Site Plan Review

Reviewed for compliance to the City Ordinance, Building and Fire Codes

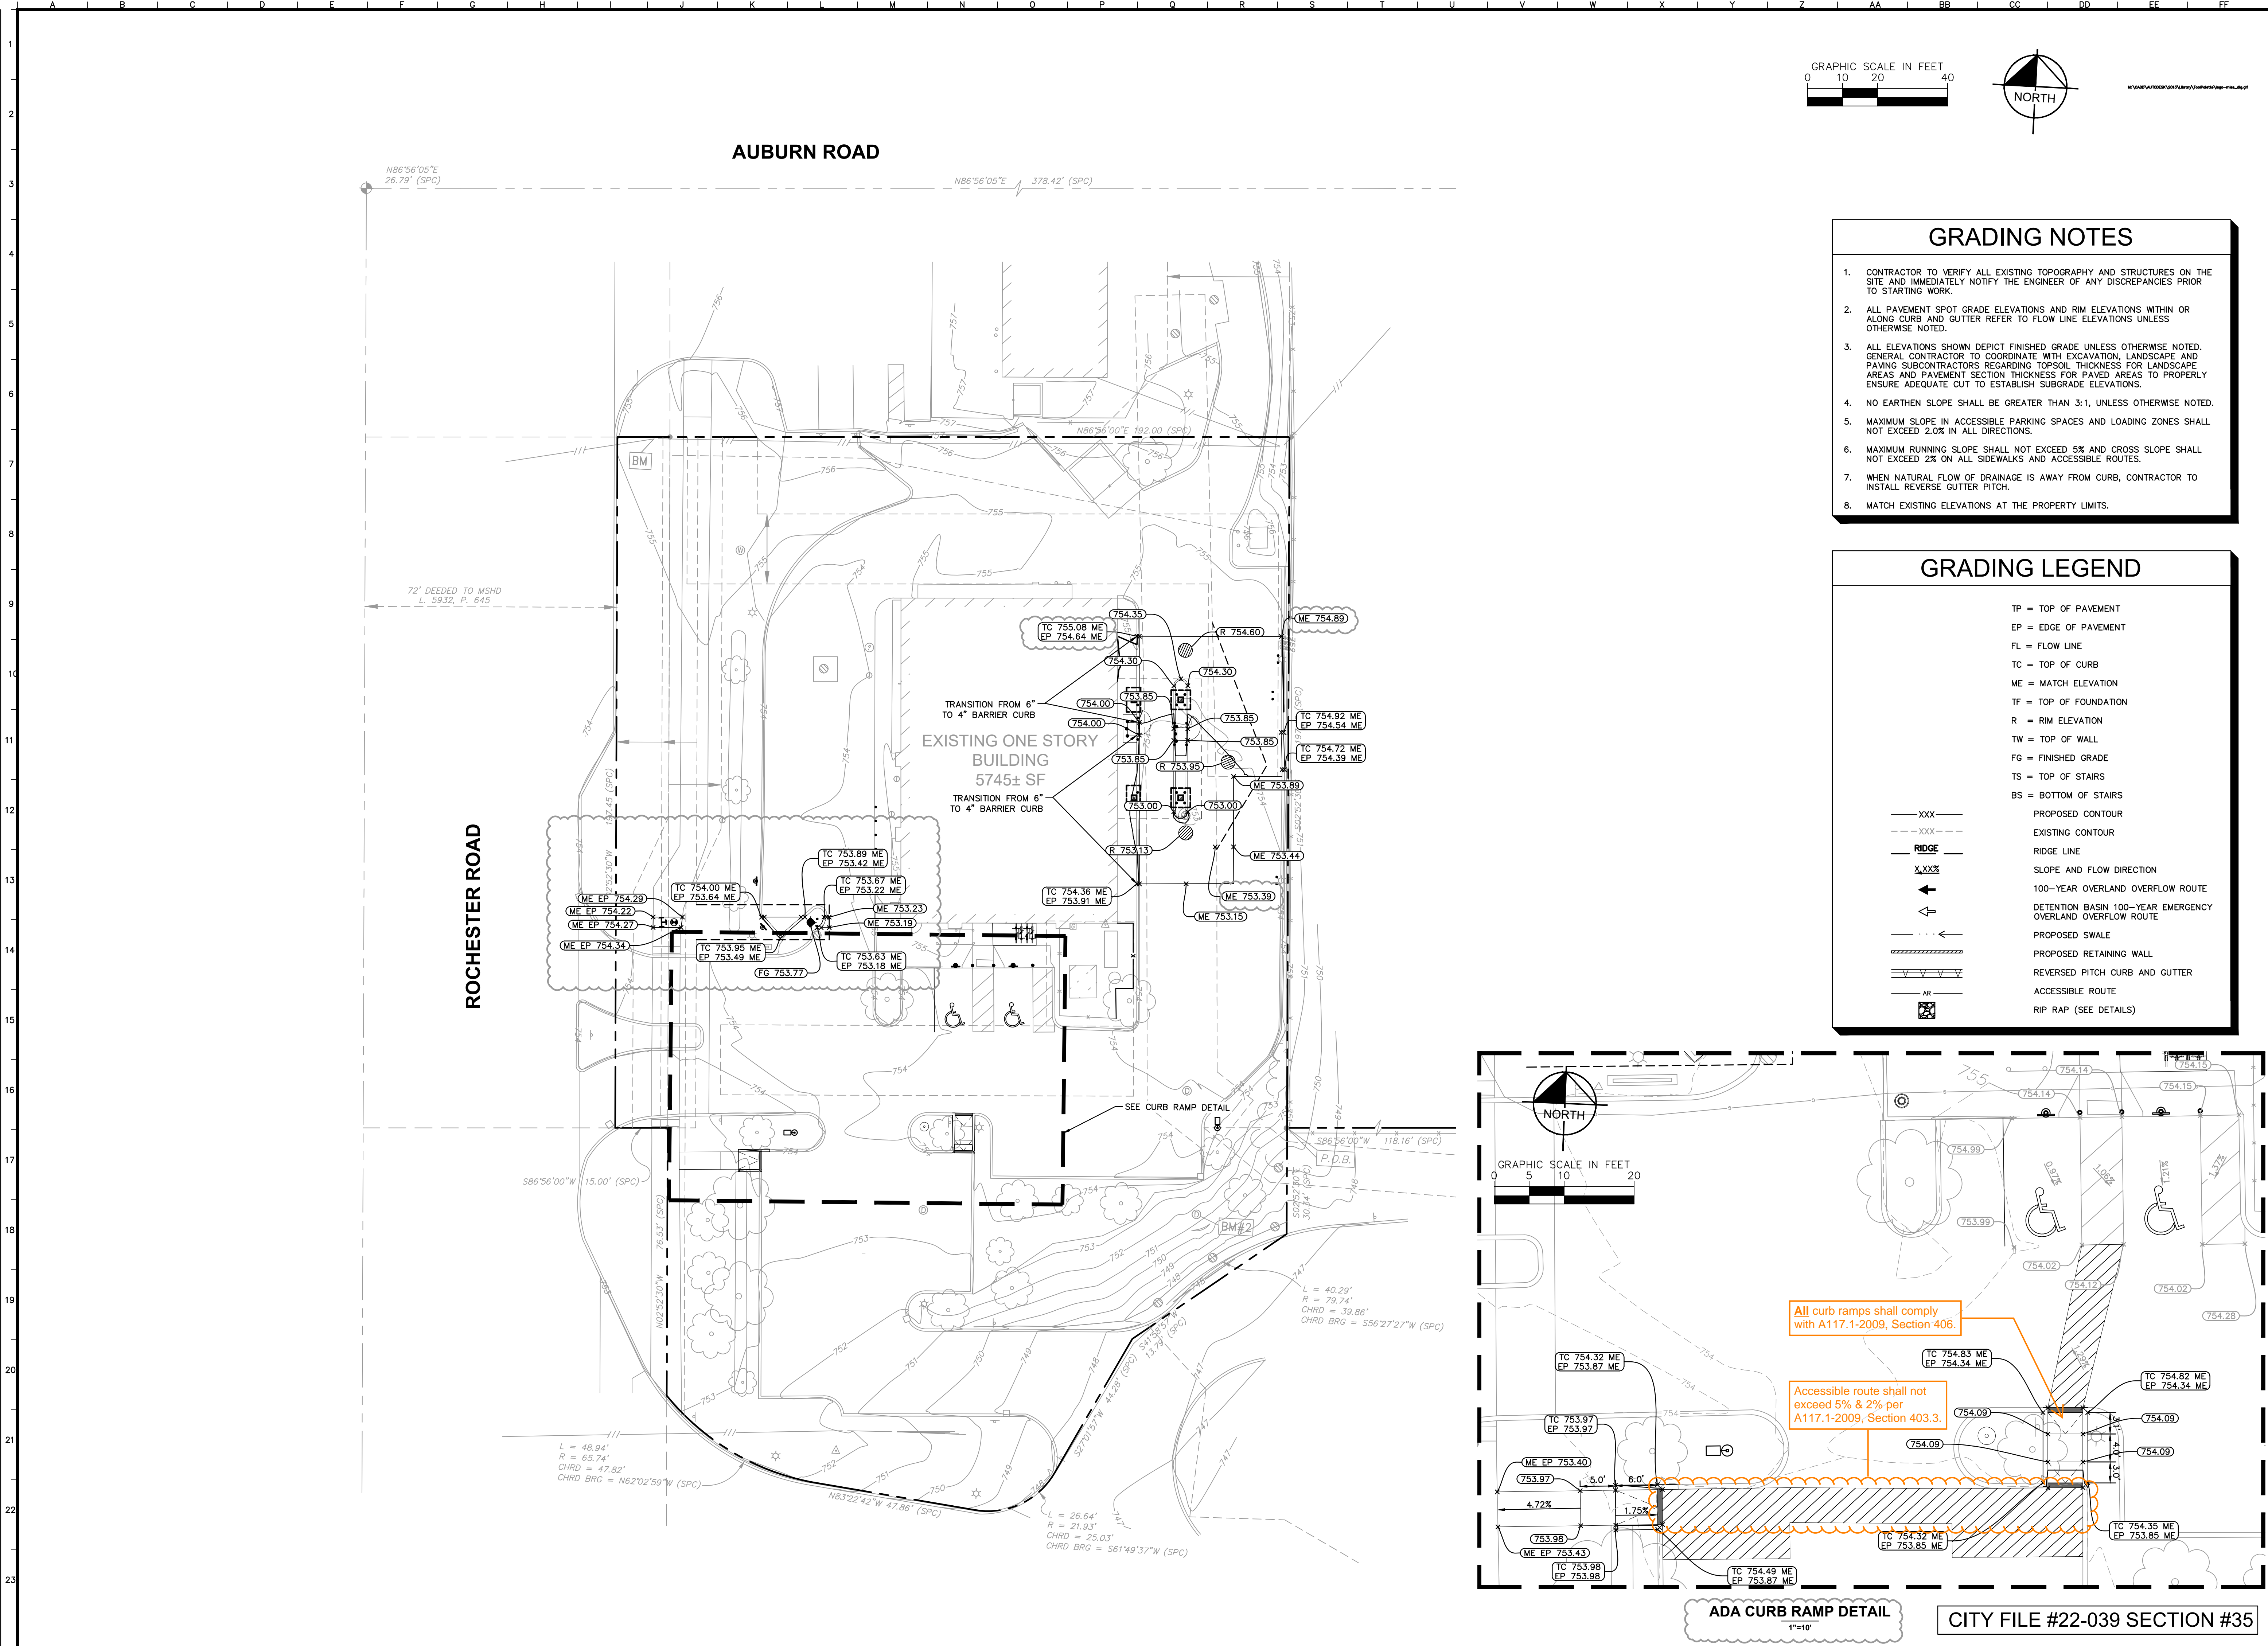
REVISED PER CITY COMMENTS
ISSUED FOR PERMIT
100% CONSTRUCTION DOCUMENTS

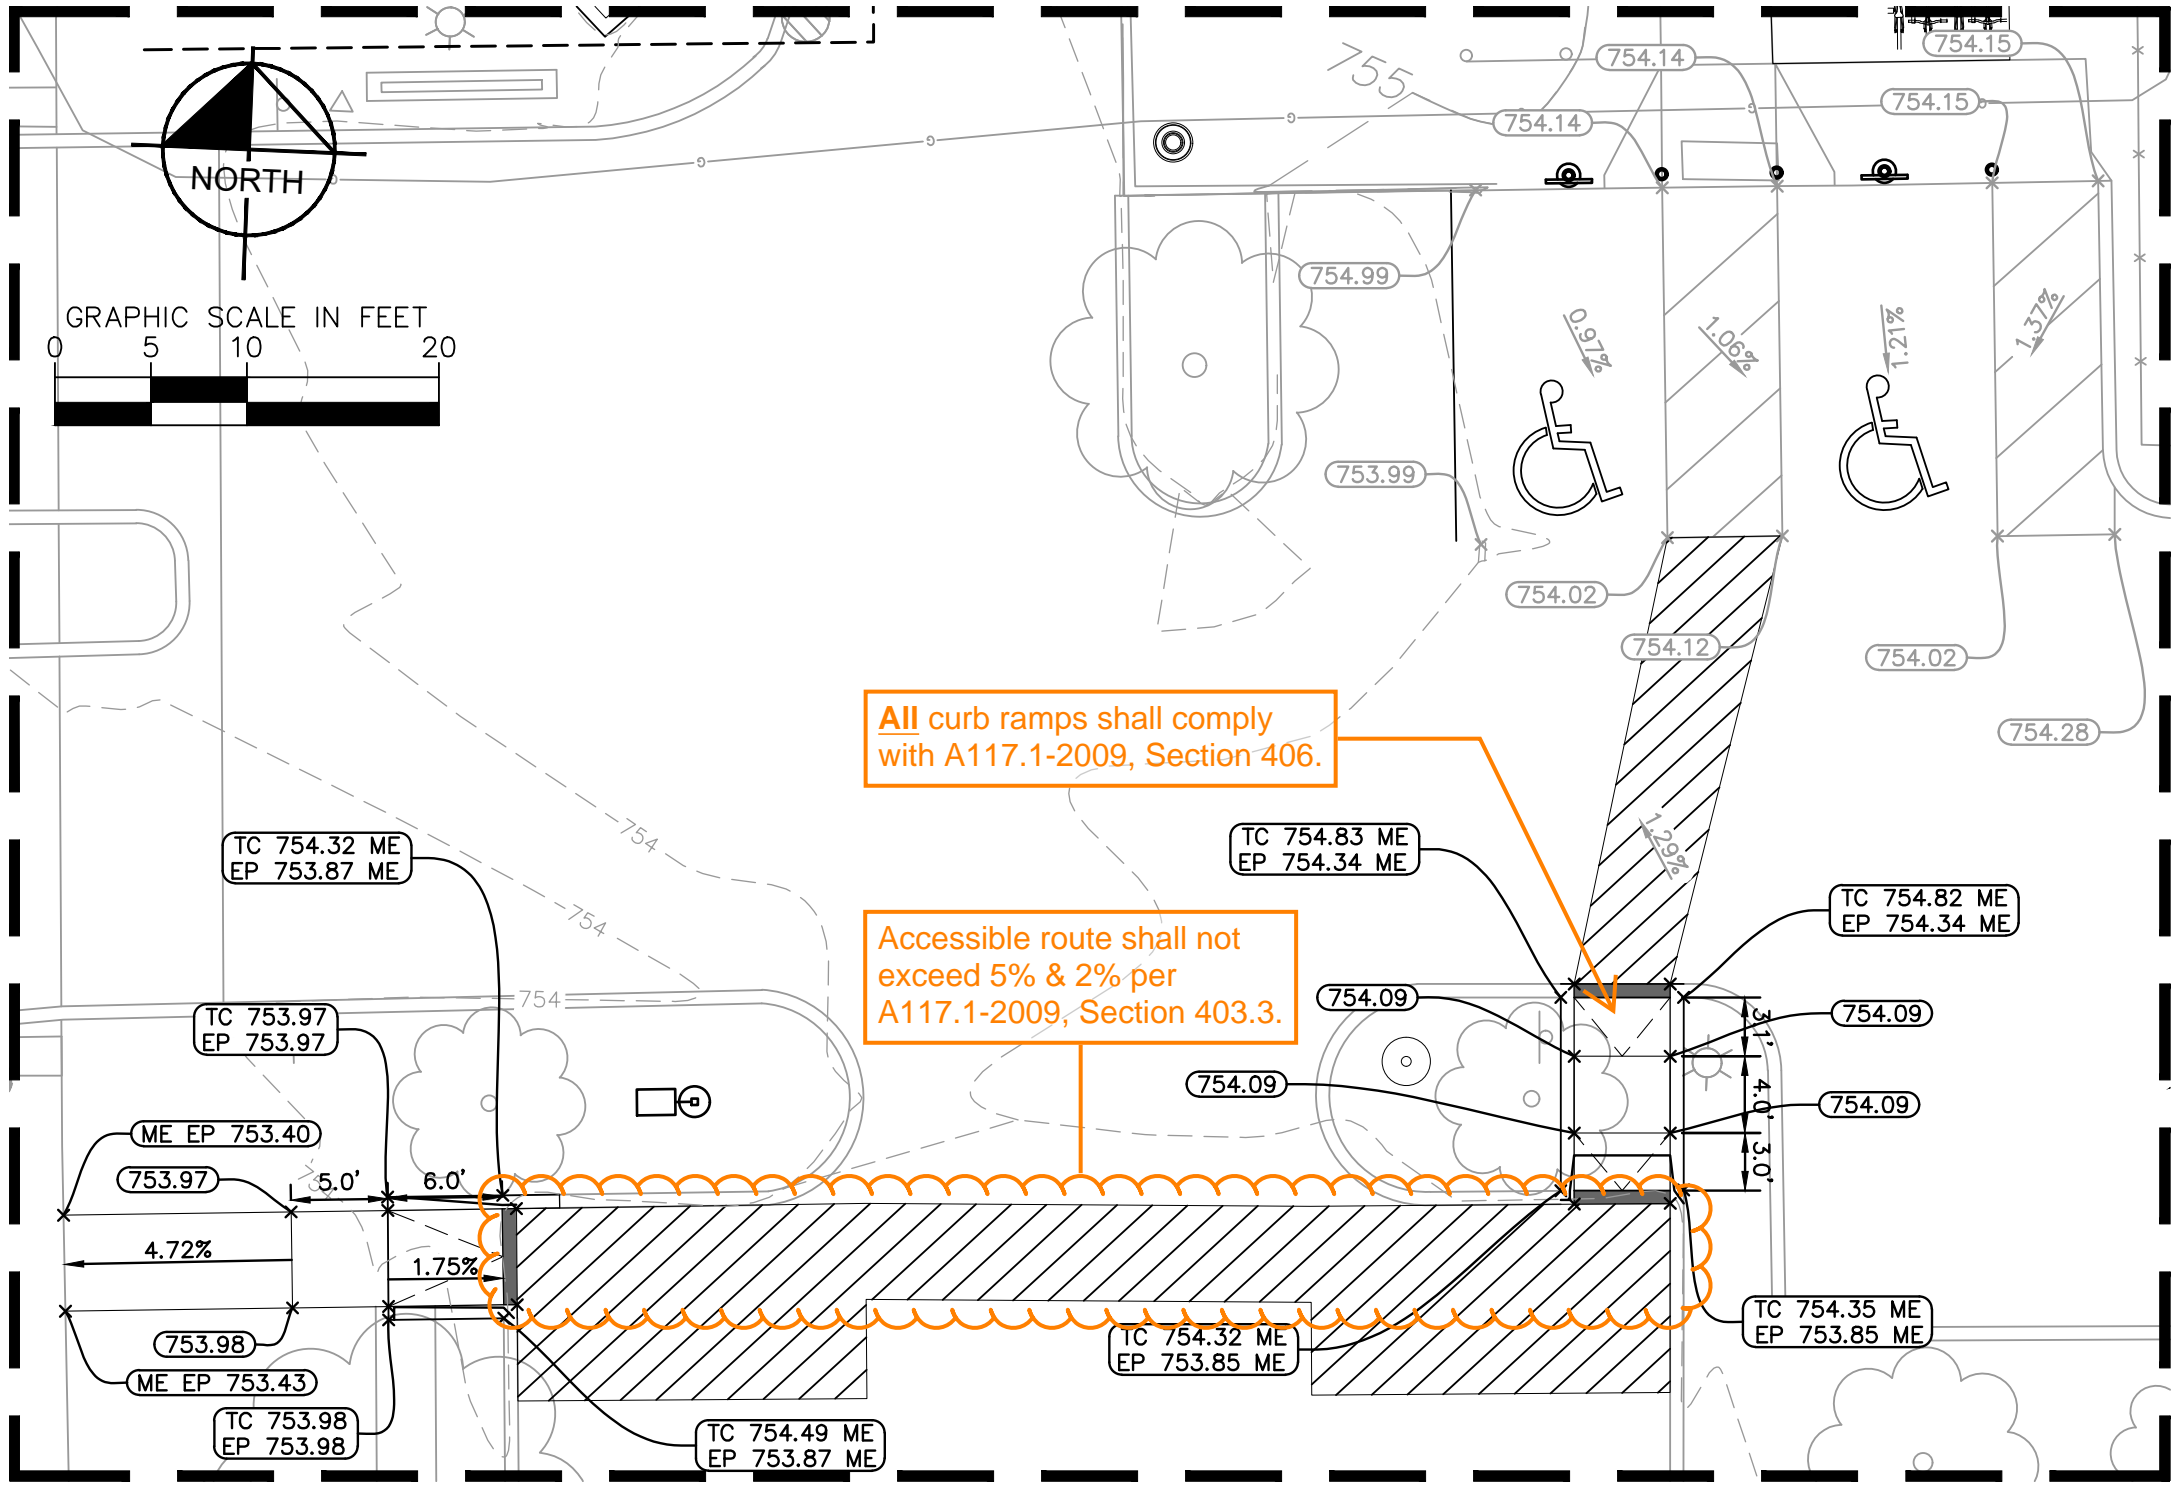
DATE	BY
12/16/22	JWG
12/19/22	JWG
02/06/23	JWG
REVISIONS	
100% CONSTRUCTION DOCUMENTS	
ISSUED FOR PERMIT	
REVISED PER CITY COMMENTS
